FINAL
Environmental Impact Report
Scannell Properties Project
Contra Costa County, California
County File #CDDP17-03045

State Clearinghouse Number 2019110186

Date: September 10, 2021

Exhibit 2-7
Spheres of Influence of Affected Cities

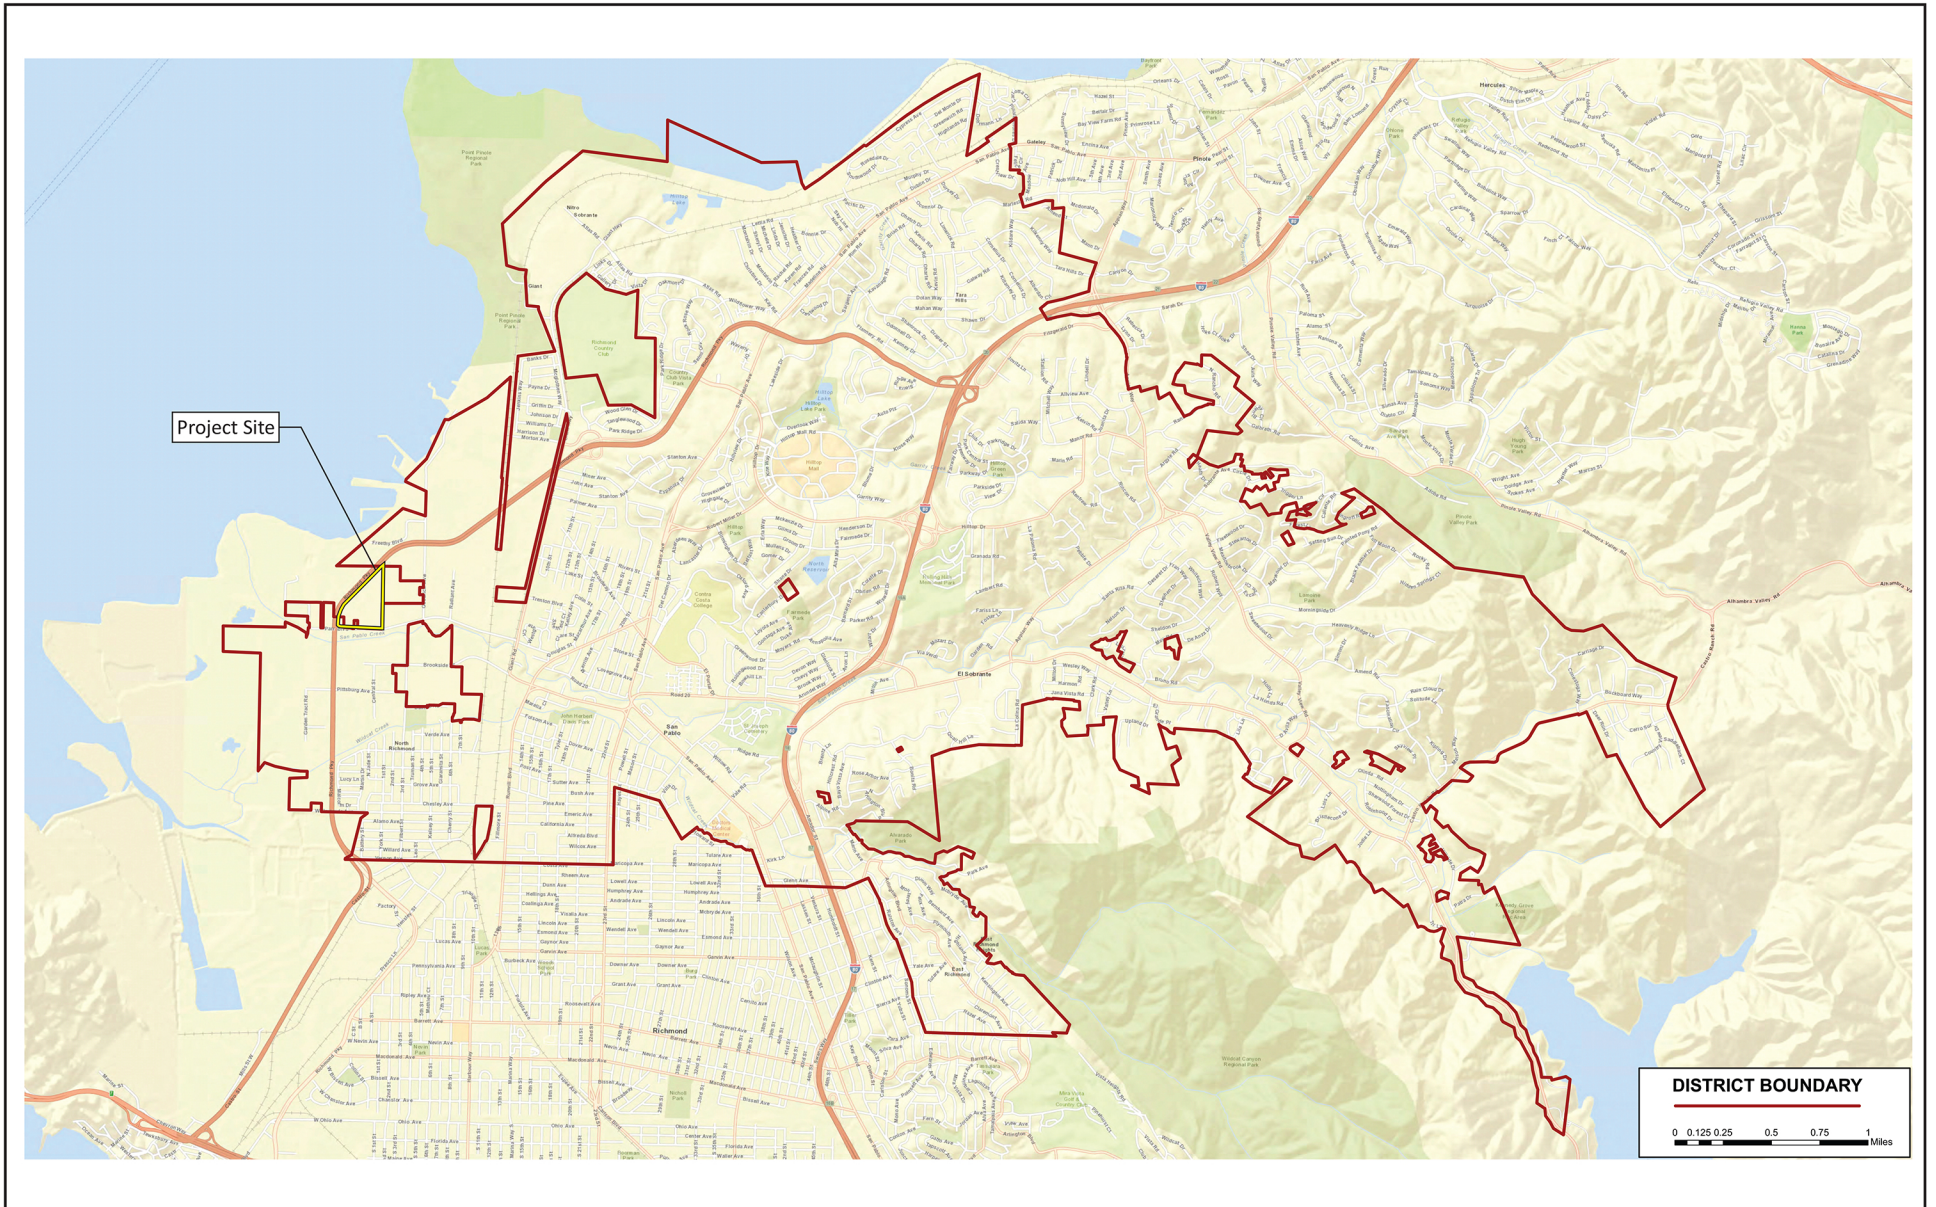
The commenter requests that a map showing the project site in relation to the Sphere of Influence (SOI) of affected cities and special districts be included in the Draft EIR. The commenter also thanks the County for the opportunity to comment on the Draft EIR.

The comment is noted. In response to this comment, Exhibit 2-7 has been prepared and included in Section 2, Project Description, of the Draft EIR (see Section 3, Errata, of the Final EIR). These changes represent minor clarifications and amplifications. None of these changes would result in a new significant environmental impact.
